Access Compliance Report Public Rights-of-Way (Curb Ramps)

Main Street: OAK_KNOLL_DR		Cross Street: SILVER_FOX_RD		Location:	NW
ADA ID: RPRK211220123418	Ramp Type:Type 1 - Perpendicular Diagonal Initial Pass/Fail: Fail		Overall Compliance: No	Severity Score:	16
Codes/Mitigation Info/Possible Solution			Field Measurements/Component Compliance

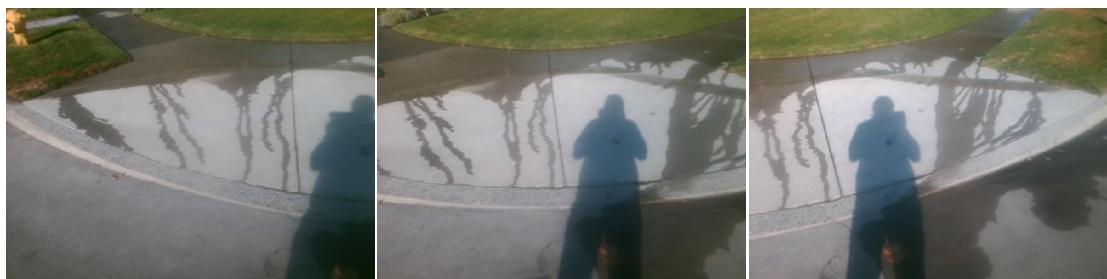
R204.3, R304.2.2, R302.7.2, STD 1115

Remove & Replace Curb Ramp With Two New Directional Ramps or Equivalent. Grind Gutter Lip.
